PLAT NO. 220081430

Ancient Oak West

RECORD PLAT REVIEW SHEET

Plat Name: Ancient Oak West Plat Number: 220081430
 Plan Name: Ancient Oak West Plan Number: 120030030
 Plat Submission Date: 2-28-08
 DRD Plat Reviewer: S. Smith
 DRD Prelim Plan Reviewer: R. Weaver Checked: [Signature] Date 4/9/08

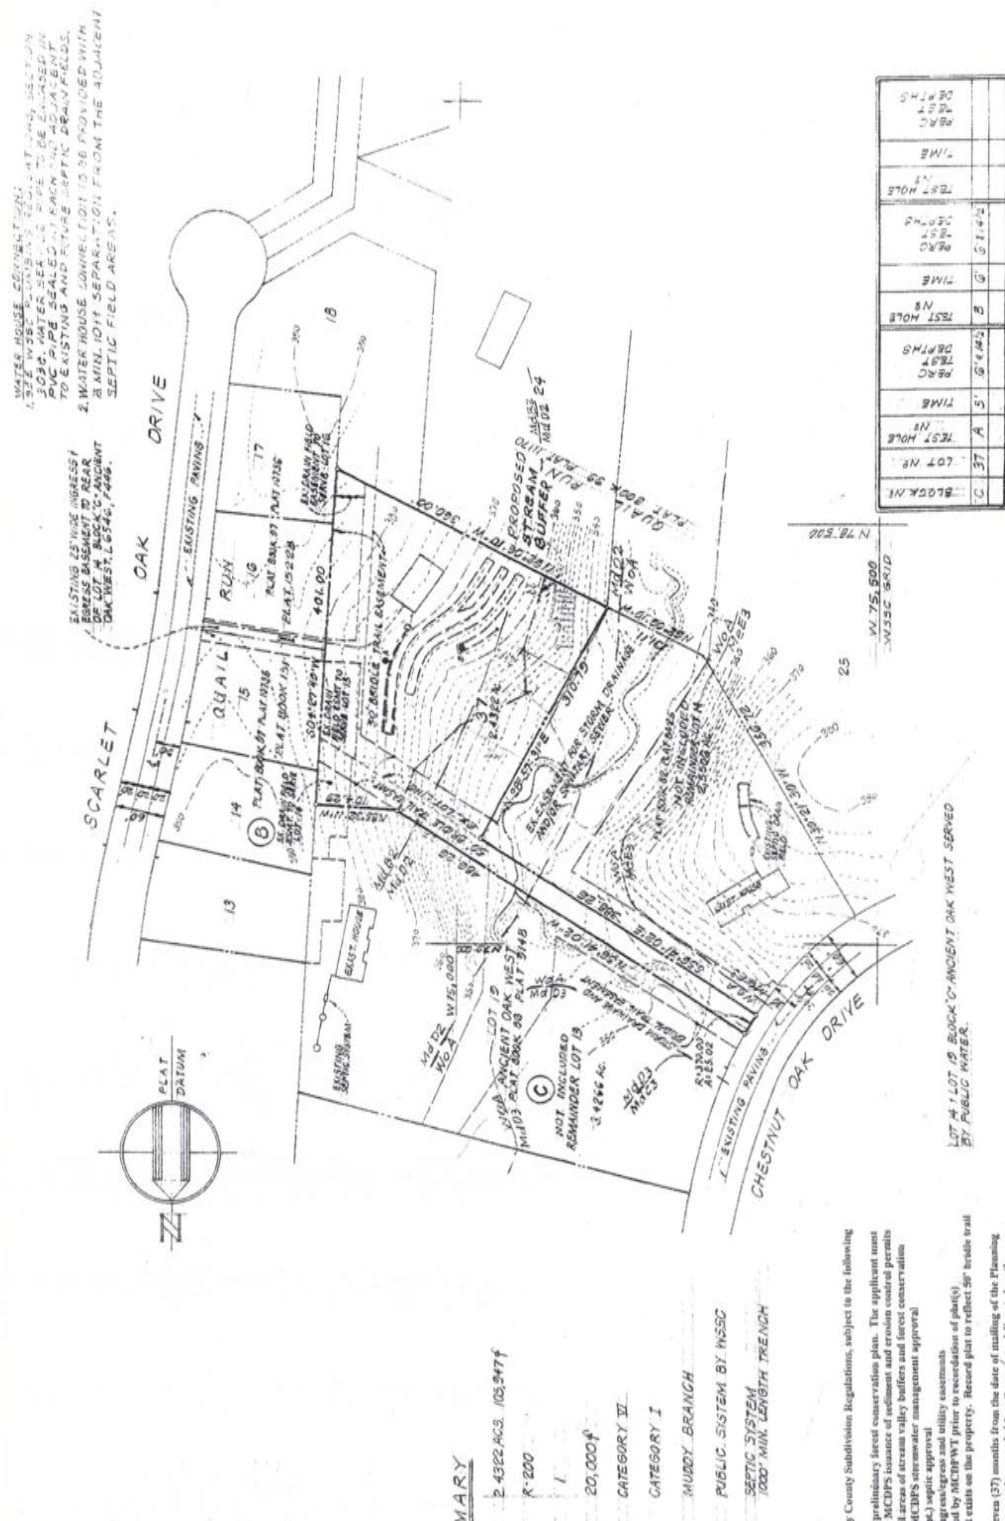
Agency Reviews Req'd	Reviewer	Date Sent	Due Date	Date Rec'd	Comments
Environment	<u>J. Penn</u>	<u>3-5-08</u>	<u>3-19-08</u>	<u>3-13-08</u>	<u>Remove FP/SBuffer Easement</u>
Research	Bobby Fleury	↓	↓	<u>3-5-08</u>	<u>OK</u>
SHA	Doug Mills	↓	↓	—	—
PEPCO	Steve Baxter	↓	↓	—	—
Parks	Doug Powell	↓	↓	—	—
DRD	Nellie Carey	↓	↓	<u>3-10-08</u>	<u>OK</u>
